SRF No. 0148483
 County Project No. 091101

**CSAH 112 – Phase 1
 Project Advisory Committee (PAC) Meeting
 June 17, 2015; 8:00 am – 10:30 am
 Orono City Hall
 MEETING RECORD**

Subject: CSAH 112 Phase 1 Final Design (Willow Drive to Wolf Pointe Trail)
Hennepin County Project No. 091101

Figure 1

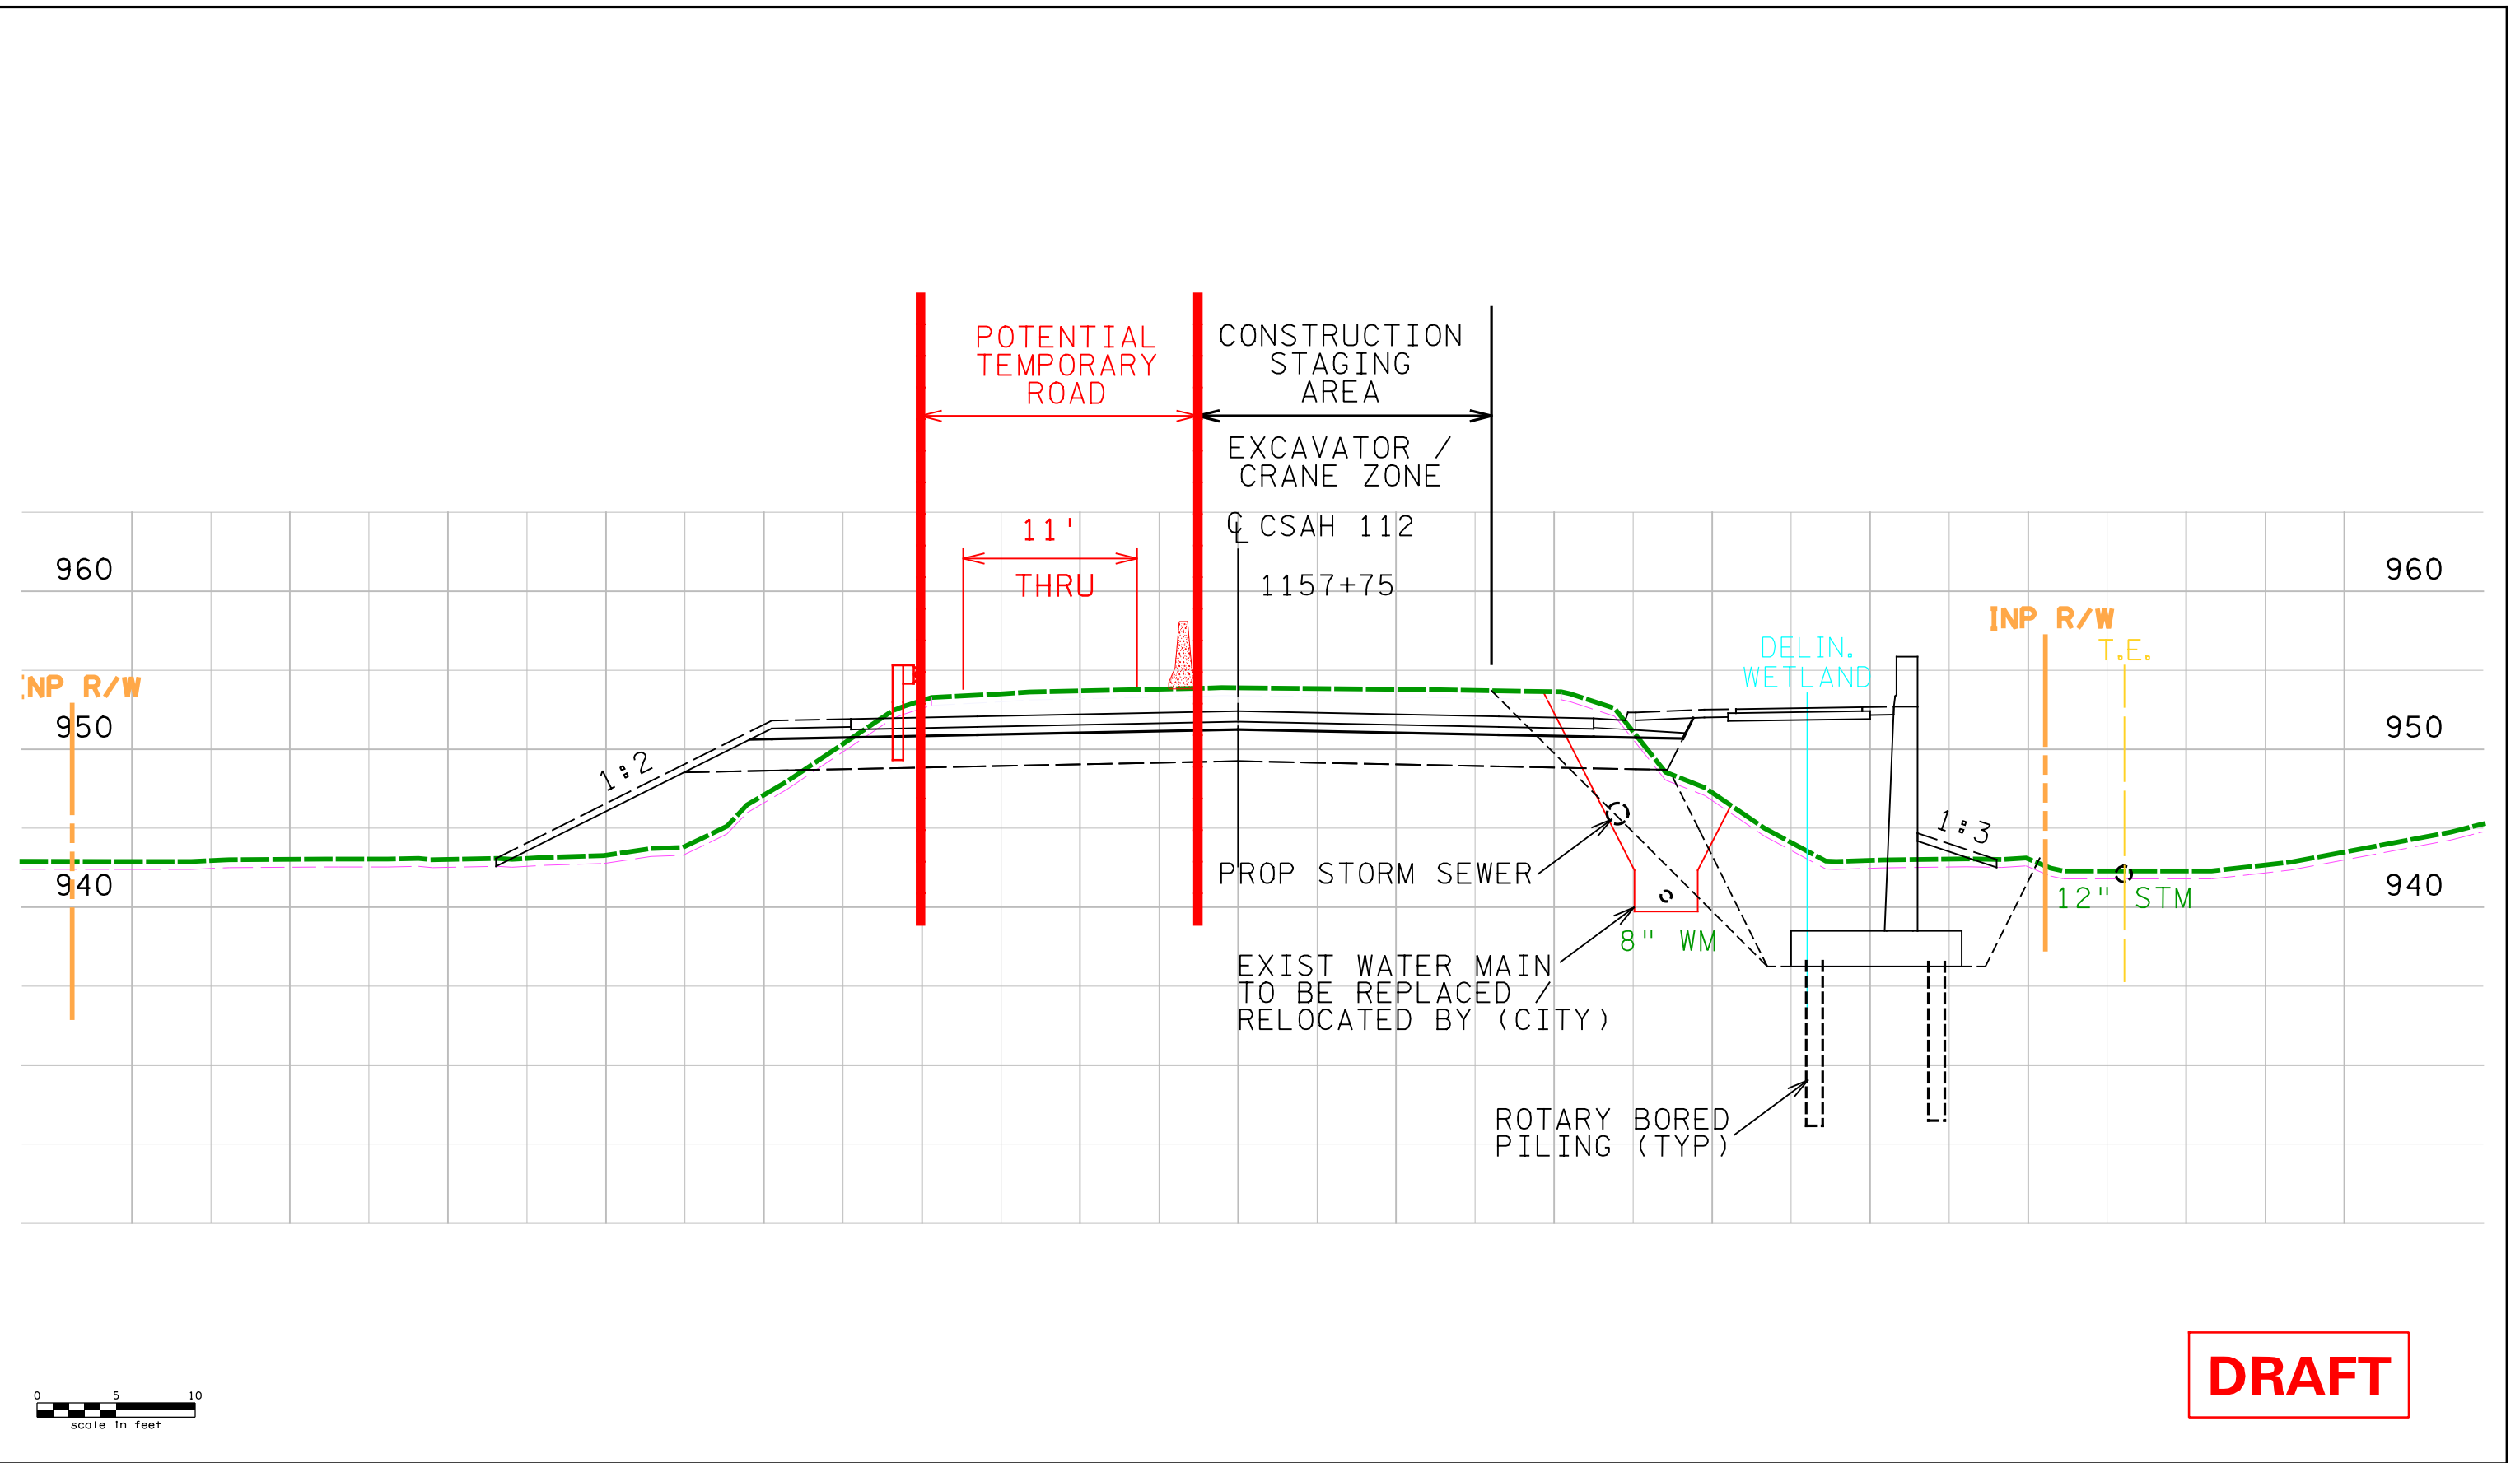
Based upon input received at the previous PAC meeting requesting consideration that at least one (1) lane be maintained during construction (no long-term closure), Nate described a conceptual staging graphic showing a cross section. A copy of this graphic (Figure 1) is attached to this meeting record. Nate noted that it's possible to construct a temporary road to pass 1-lane of traffic, one direction (east or west) along the work zone required to construct the reinforced soil slope (RSS) and culvert at Long Lake Creek. He pointed on this graphic that a 5-foot pedestrian area is included to provide temporary access for trail users on the Long Lake Trail access to downtown. A temporary wall or barrier may be required to hold back the existing berm along the south side of temporary roadway/pedestrian access.

Project Name CSAH 112
Computation for CONCEPT SHEET FILE WALL

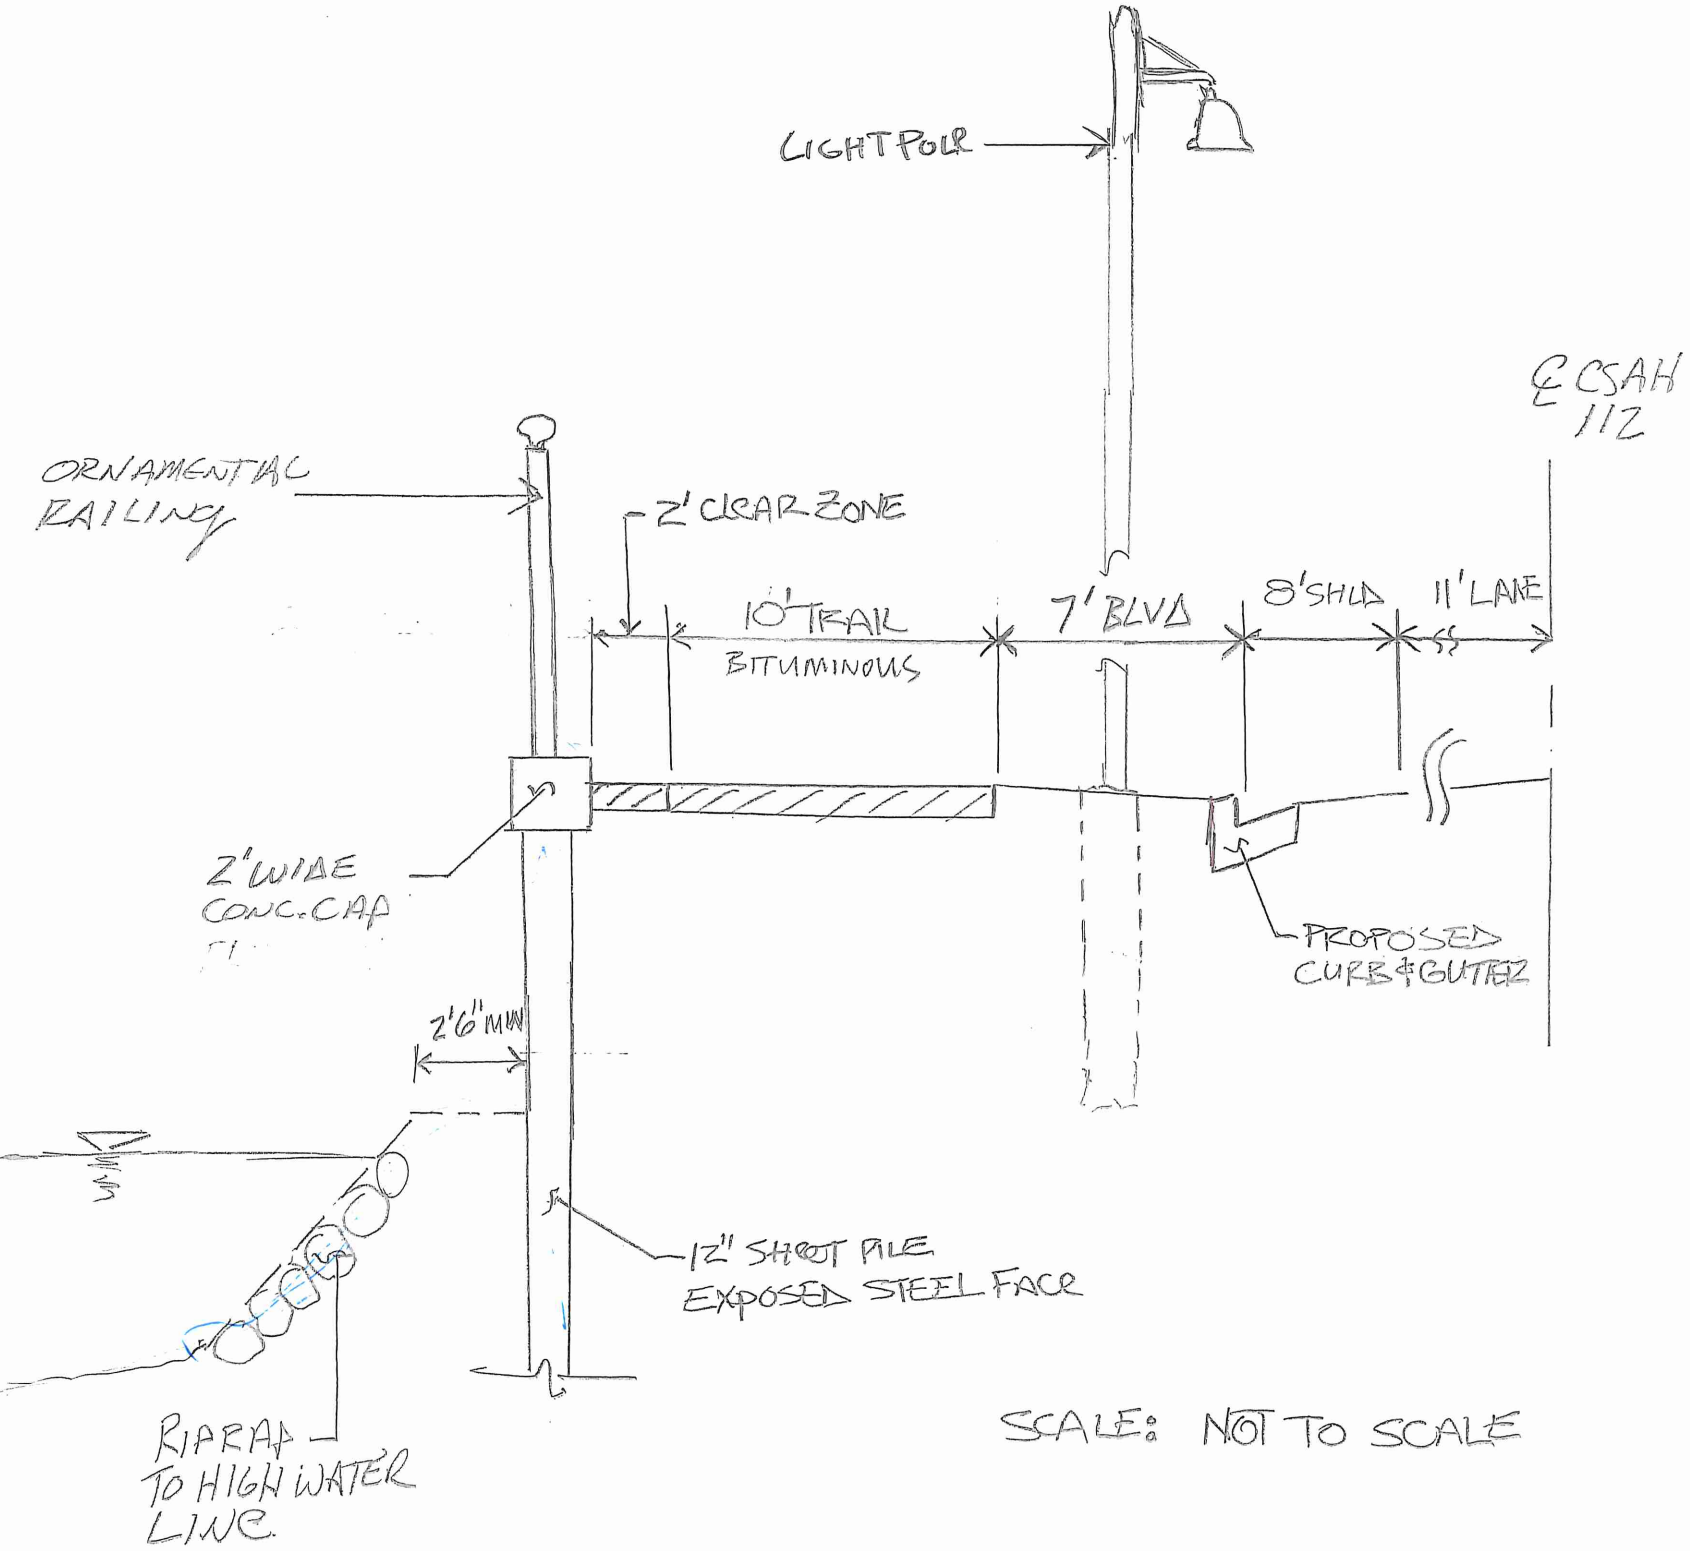
The County reviewed the potential for switching the RSS to a permanent steel sheet pile wall for the shoreline restoration along Long Lake. Nate presented a hand sketch graphic and a series of construction photos that illustrate a permanent steel sheet pile wall along Long Lake. A copy of this sketch and the photos presented are attached to this meeting record. Nate pointed out a few key aspects of constructing this type of wall which include a large safety/work area to store and move the sheet pile sections. He mentioned that preliminary estimates indicate the length of sheet pile to be a minimum of 40-foot which requires substantially large equipment to haul, unload and install.

Nate noted that a previous project constructed along Medicine Lake was bid a few years ago while allowing traffic to remain on the roadway while the contractor installed the sheet pile wall. He noted the bids were few and nearly double the estimated project cost. After further consideration and discussion, the project was rebid assuming the roadway was closed to traffic and the resulting bids were near to the estimate. He noted the CSAH 112 project is very similar to this previous project and minimum work area width is nearly the same for either the RSS or a sheet pile wall. Nate indicated that additional "tie-backs" consisting of an additional sheet pile or restraints would be required through the area of poor soils near the west end of Long Lake.

Nate discussed a memorandum regarding the cost differentials for constructing either the RSS or a permanent steel sheet pile wall along Long Lake. A copy of this memorandum is attached to this meeting record. The PAC reviewed the Pro's and Con's summary included with this memorandum and agreed that constructing a permanent steel sheet pile wall was not the best option.
